Seismic Walkdown Checklist (SWC)

Equipment ID No. 1-1808-Q3-L47 Equip. Class¹² 14 (DISTRIBUTION PANELS & AUTOMATIC TRANSFER SWITCHES)
 Equipment Description EMERGENCY LTG DIST PANEL IN LPA7
 Location: Bldg. DG Floor El. 220' Room, Area R101
 Manufacturer, Model, Etc. (optional but recommended) _____

Equipment ID No. 1-1807-43-13 Equip. Class¹² 4
 Equipment Description Regulated XFMR IBBC09RX AH Feed to Panel 1A1B

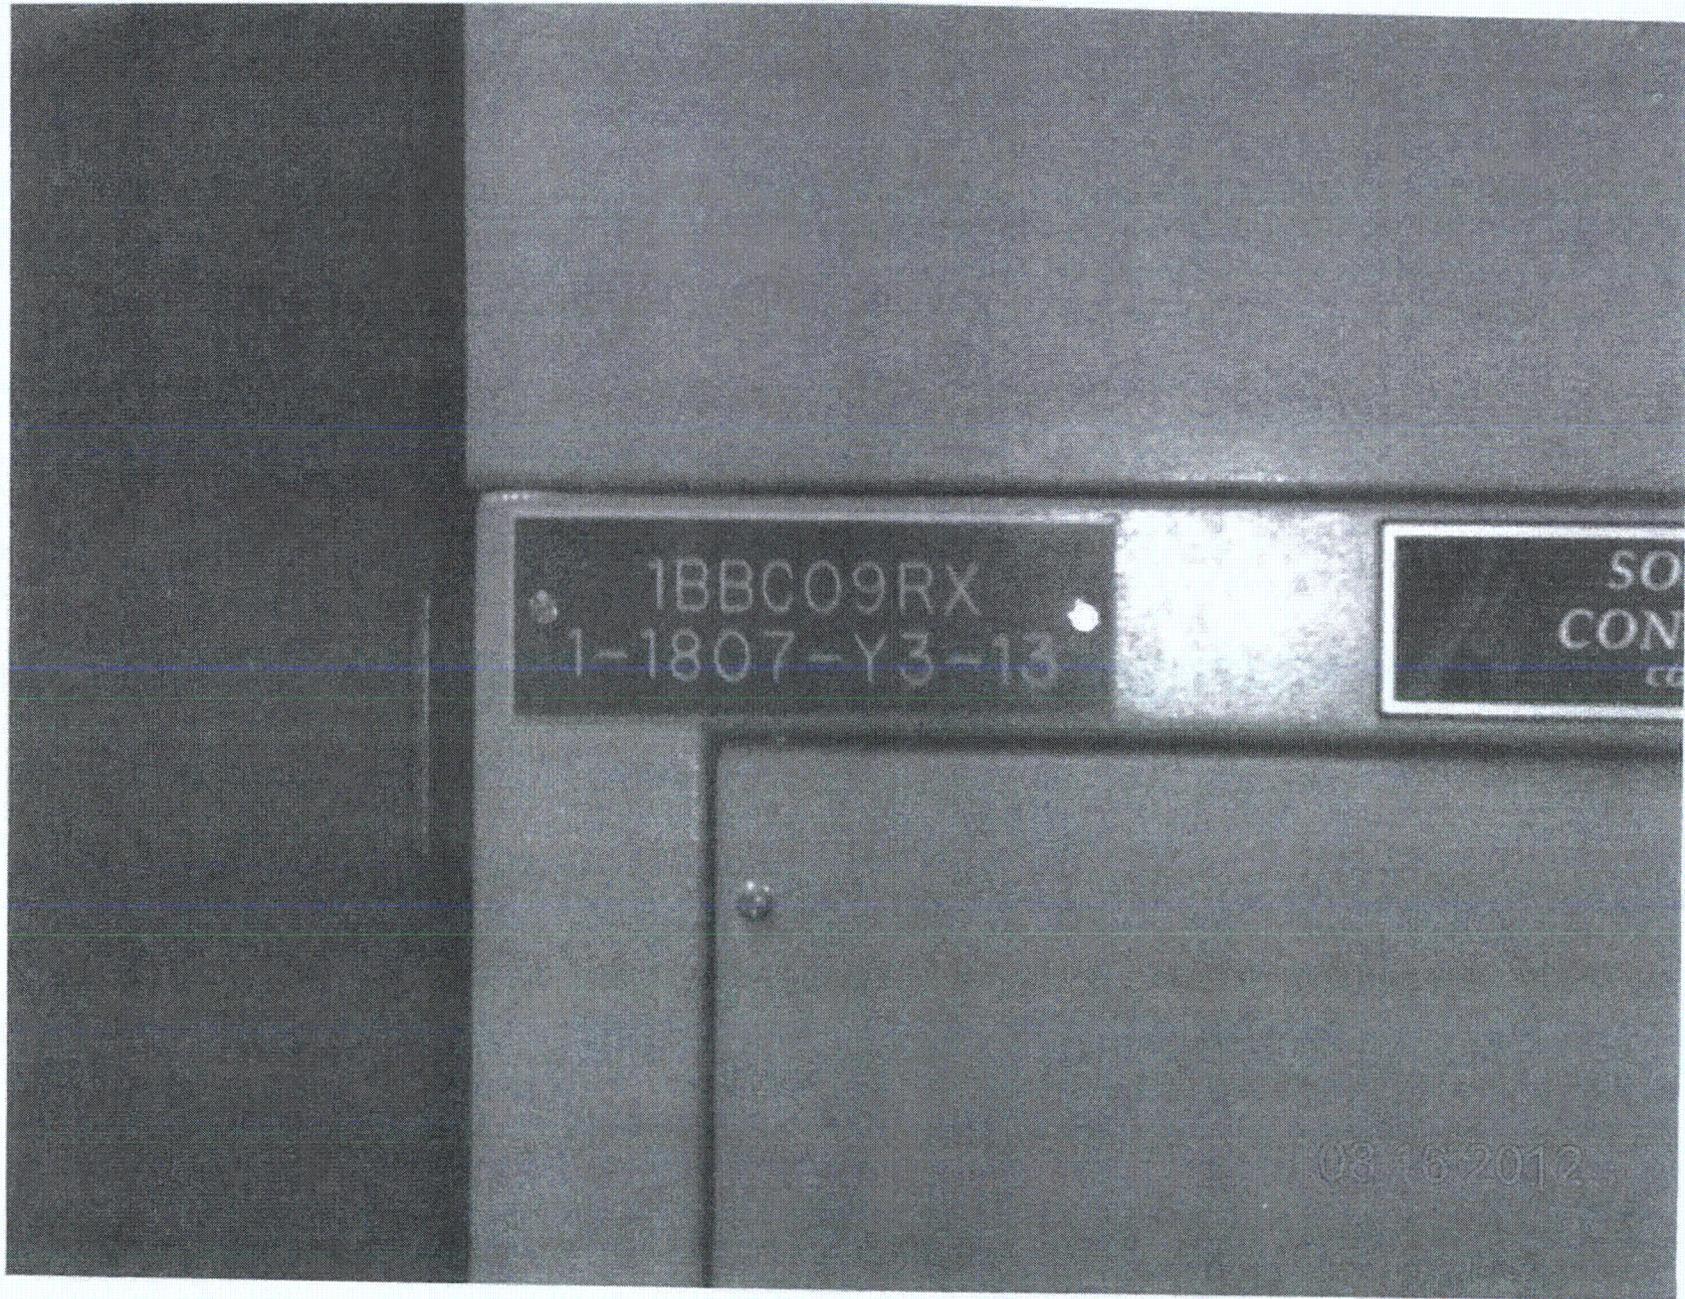
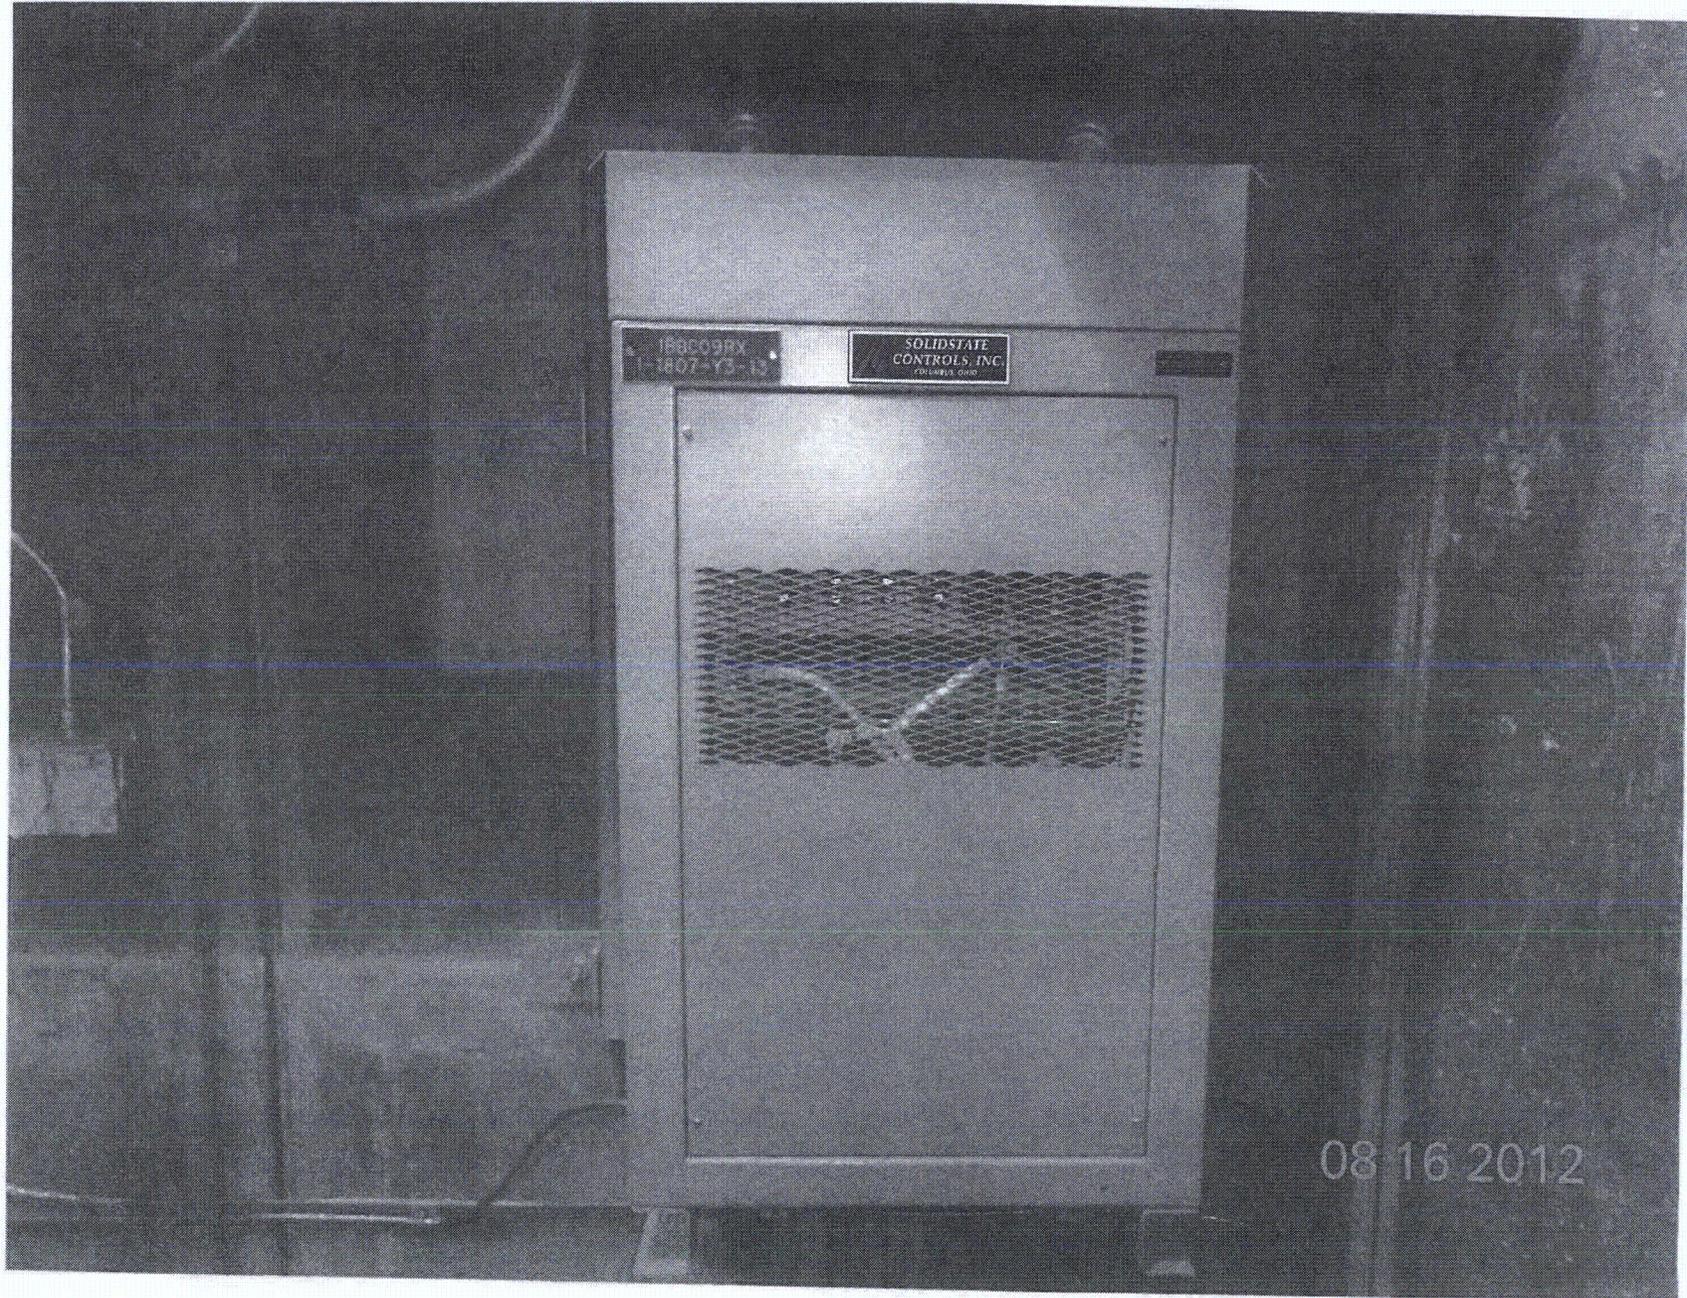
THIS COMPONENT HAS BEEN INSPECTED TO THE EXTENT PRACTICAL. ALL VISIBLE ANCHORS, HARDWARE AND SURFACES WERE INSPECTED. THE ANCHORAGE FOR THIS ITEM IS VISIBLE WITHOUT OPENING THE COMPONENT. TO INSPECT THE COMPONENT FURTHER WOULD REQUIRE DISASSEMBLY. SINCE THE ANCHORAGE IS VISIBLE, THE INSPECTION MEETS THE REQUIREMENTS OF THE GUIDANCE DOCUMENT.

Equipment ID No. 1-1816-03-017 Equip. Class¹² 20 (I²C Panels)
 Equipment Description Auxiliary Relay Panel
 Location: Bldg. Control Floor El. 200' Room, Area RA 45
 Manufacturer, Model, Etc. (optional but recommended) RELIANCE CUSTOM CONTROL

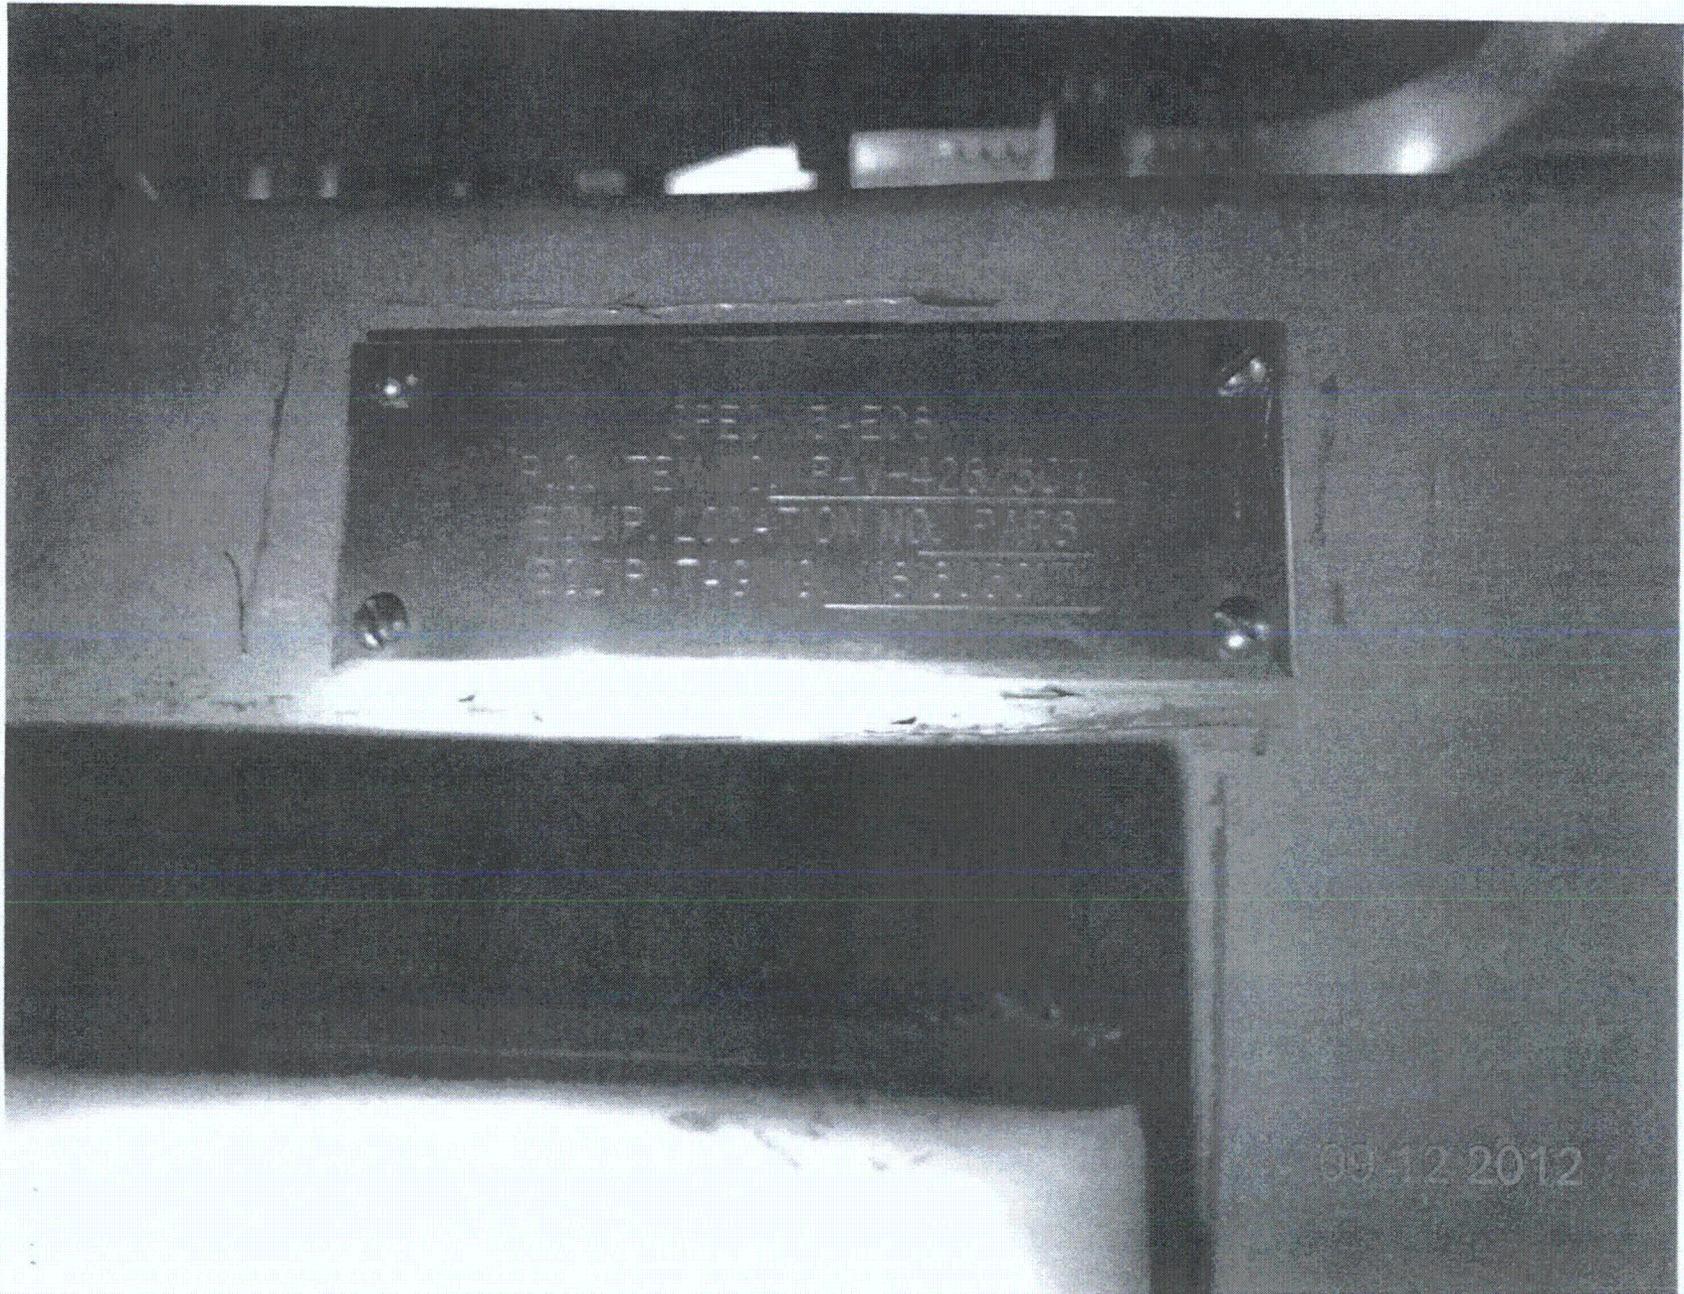
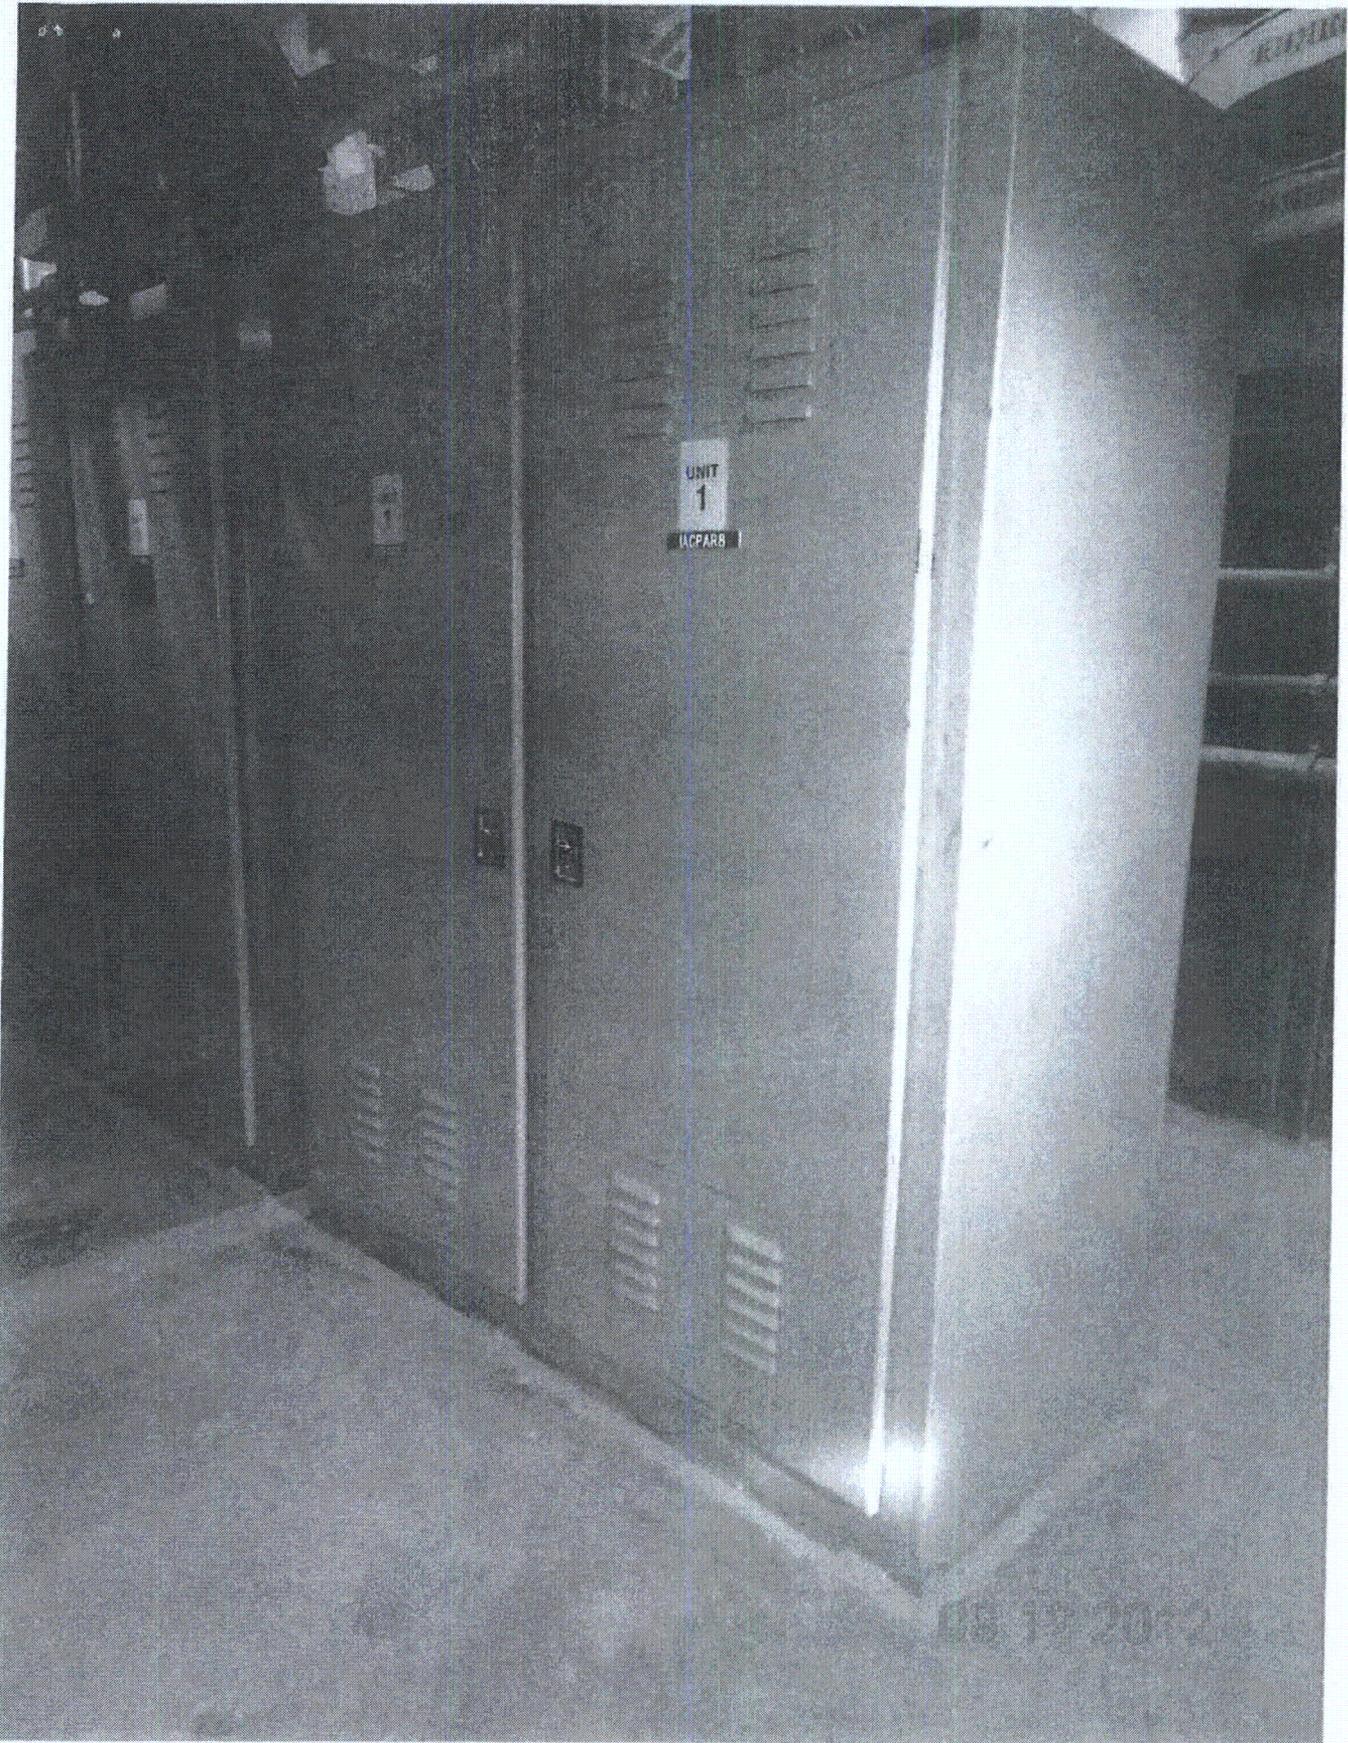
4. Is the anchorage free of visible cracks in the concrete near the anchors? Y N U N/A
welded anchorage to embedded steel.
